ADDENDUM NO. 01

July 24, 2026

**Bradford Exempted Village Schools
New Athletic Facility
760 Railroad Avenue
Bradford, OH 45308**

LPA PROJECT NO. 263401.00

FIRST FLOOR AND MEZZANINE FLOOR PLANS - POWER & SYSTEMS

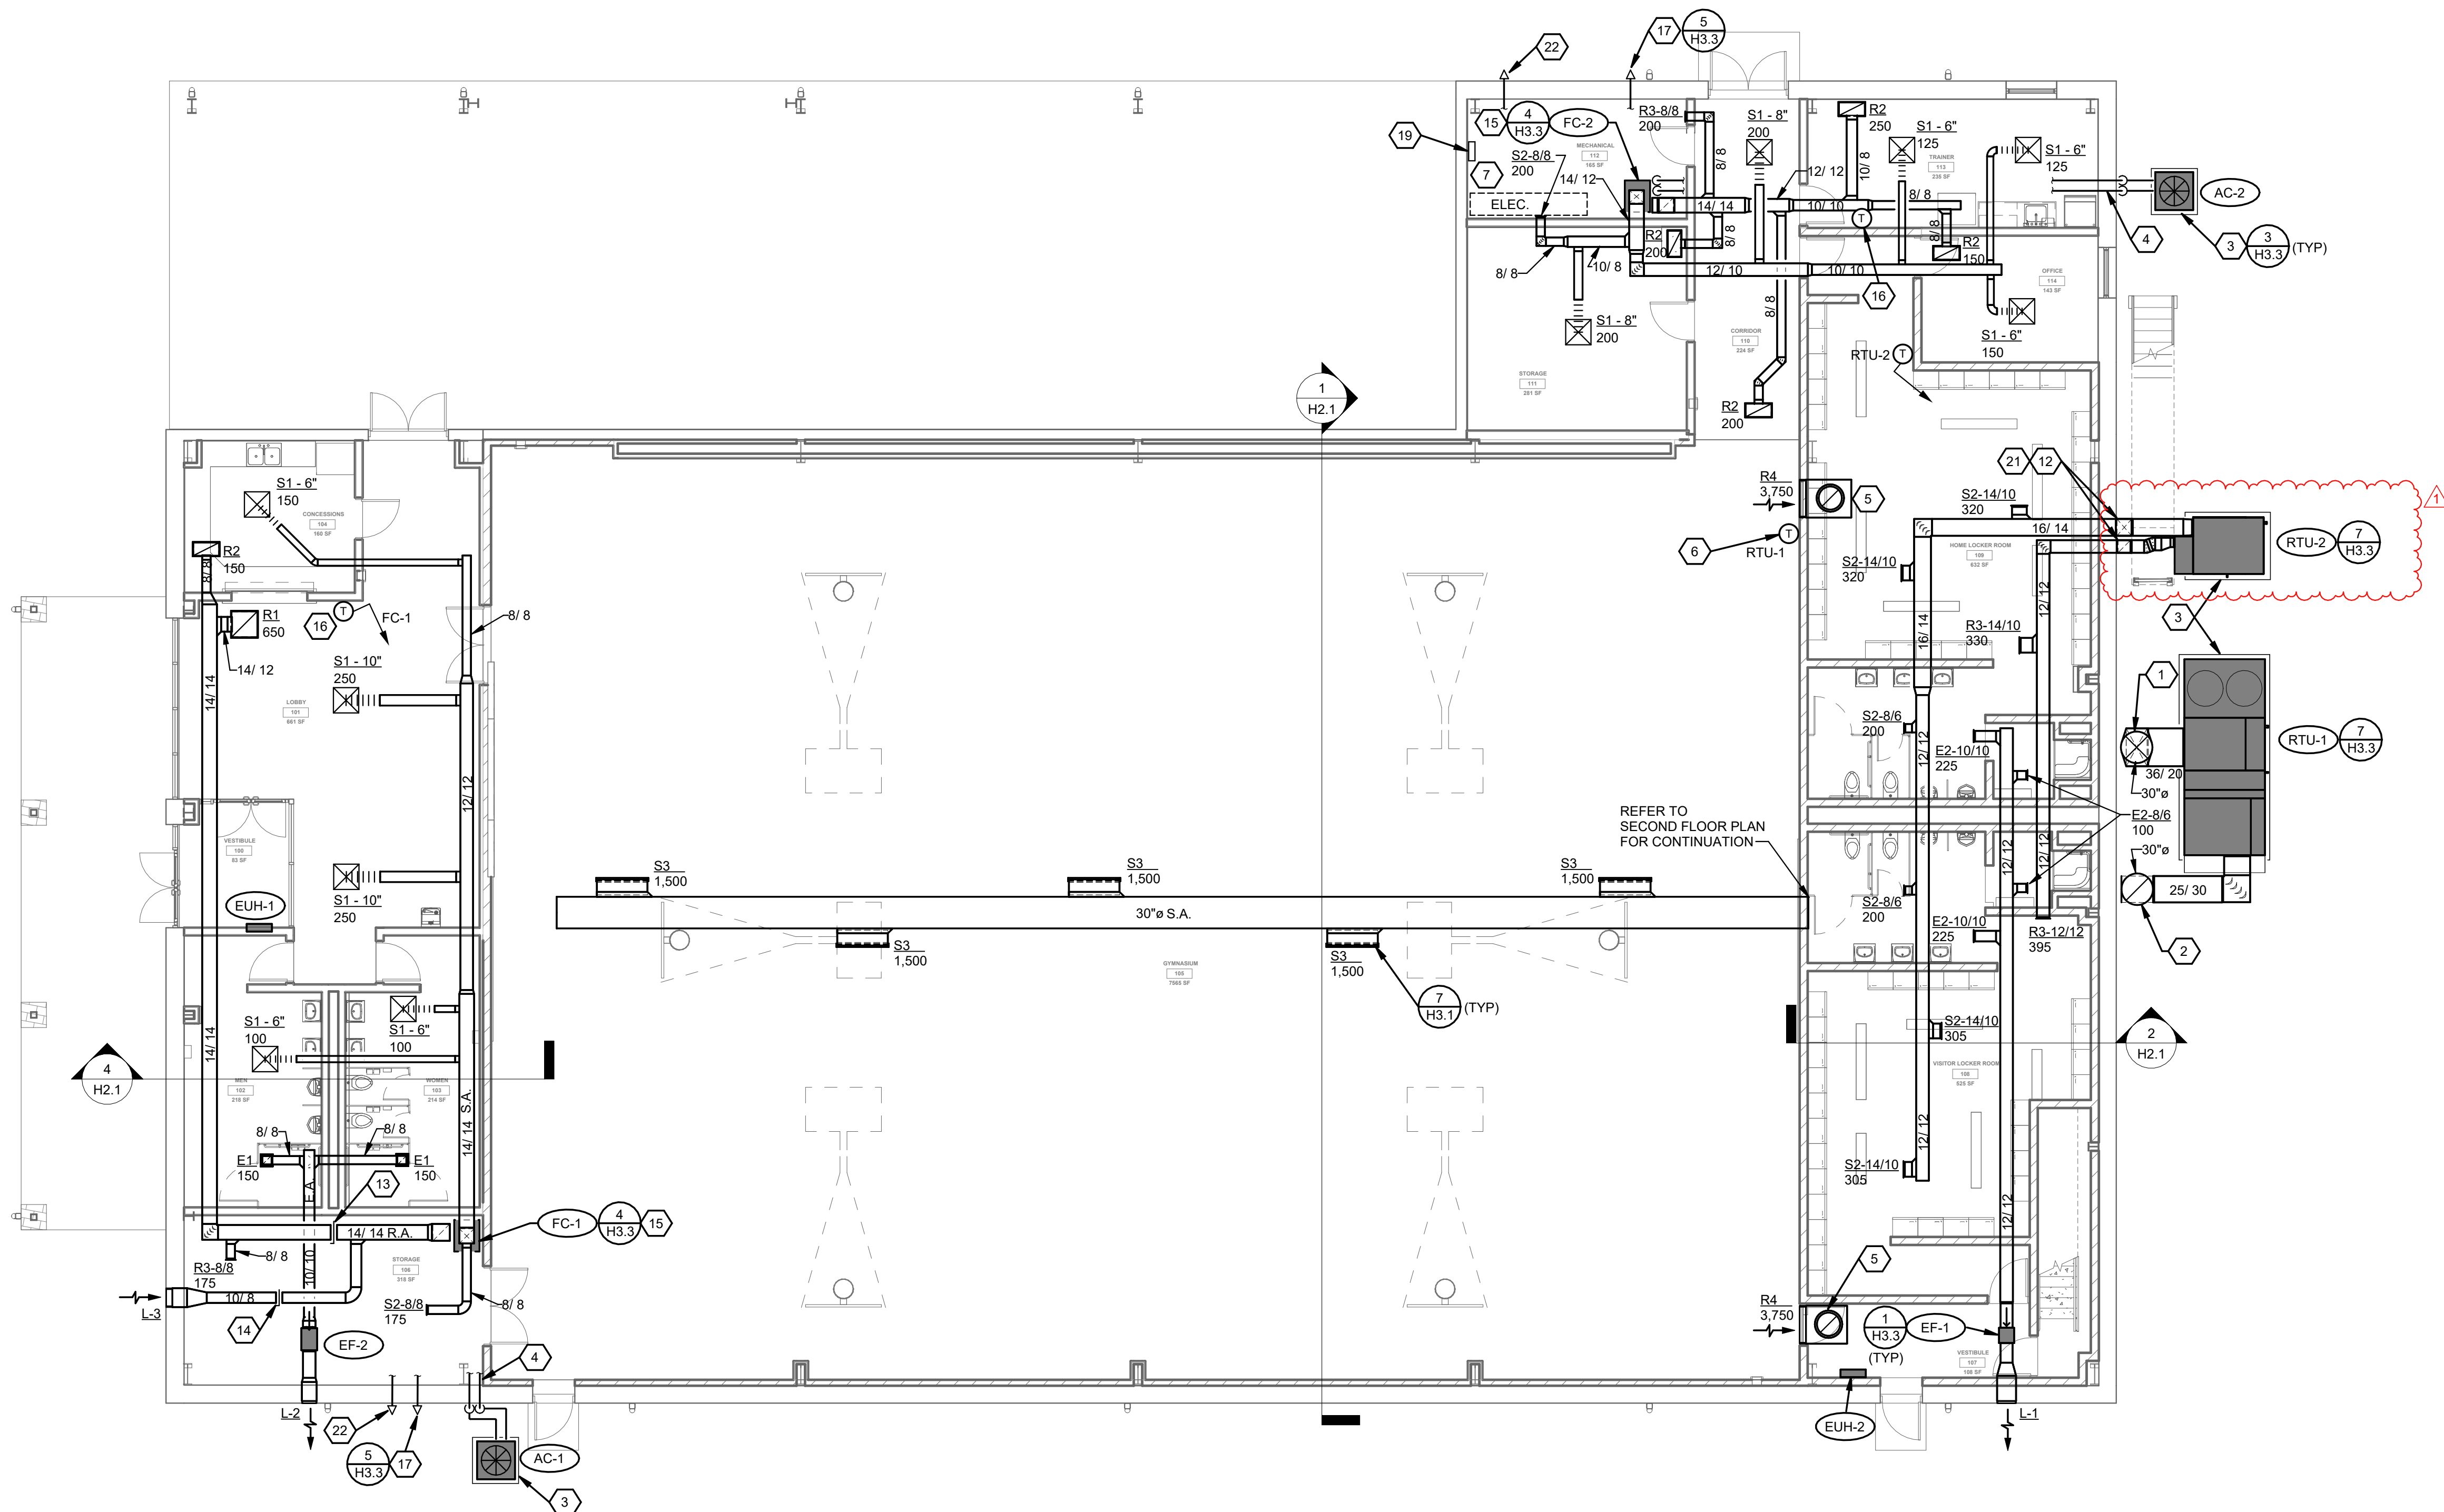
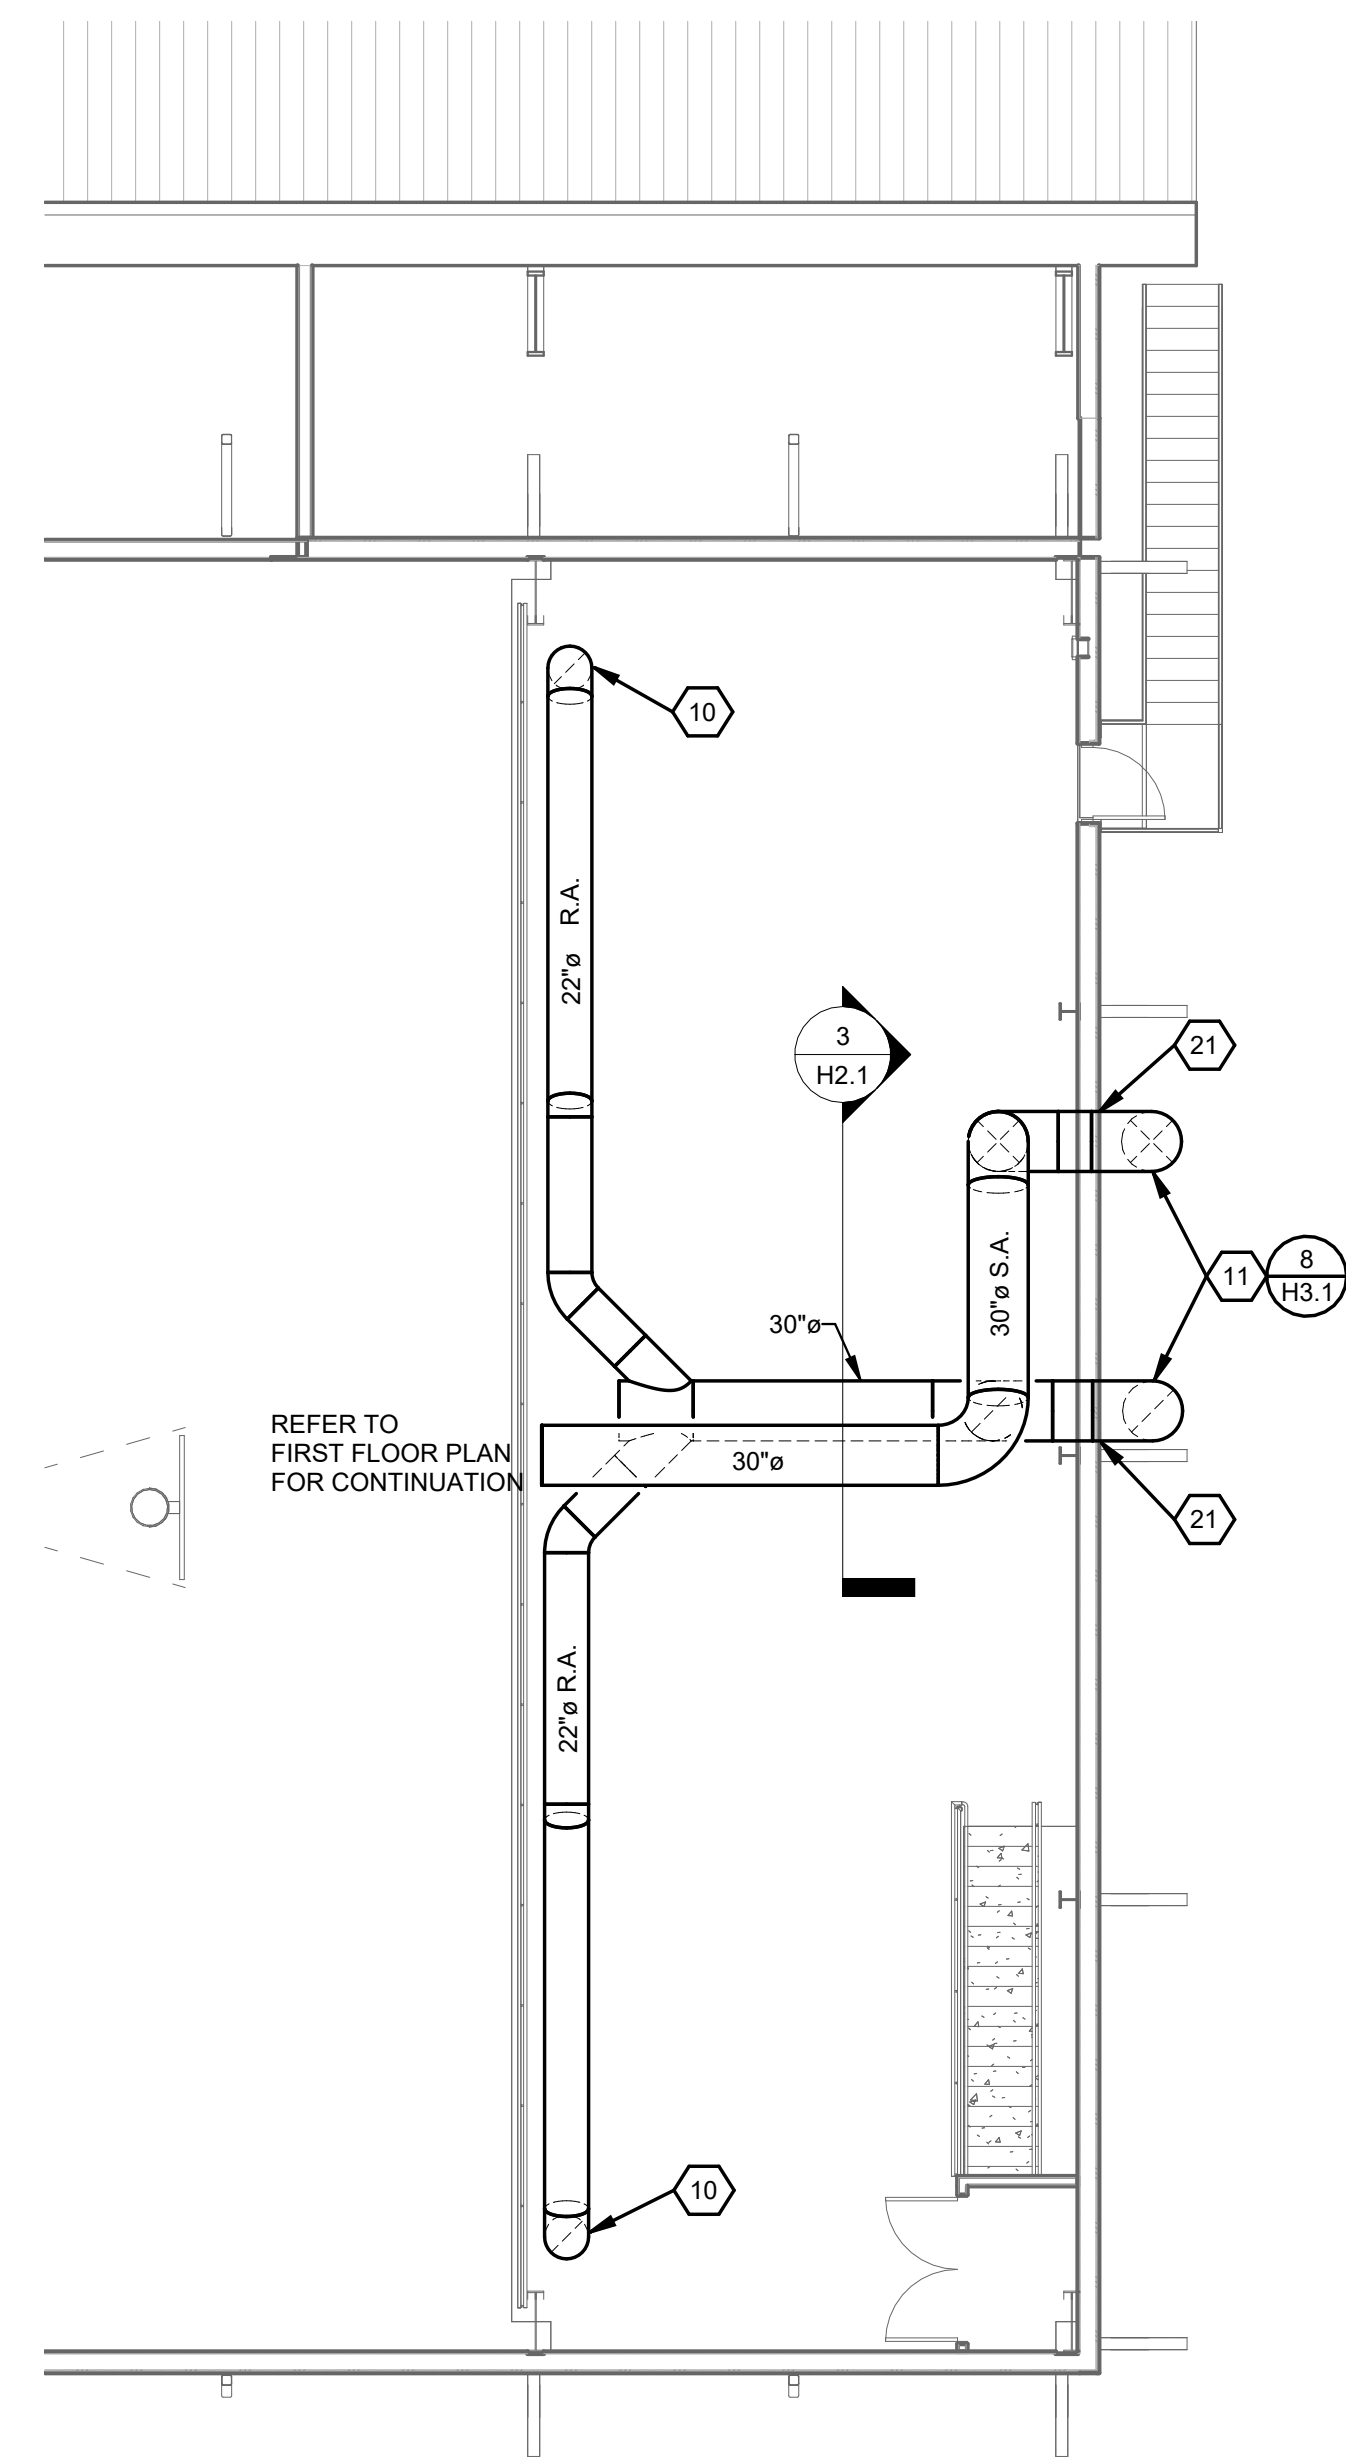
2.24 Sheet E1.2 – FIRST FLOOR AND MEZZANINE FLOOR PLANS – POWER AND SYSTEMS.

2.24.1 Bleacher Alternate G-2 has been deleted and bleachers will be provided by Owner at a later date. Please note that rough-ins for the future bleachers shall be included in the base bid. Revise notations for bleacher services as applicable. Refer to drawing issued with Addendum.
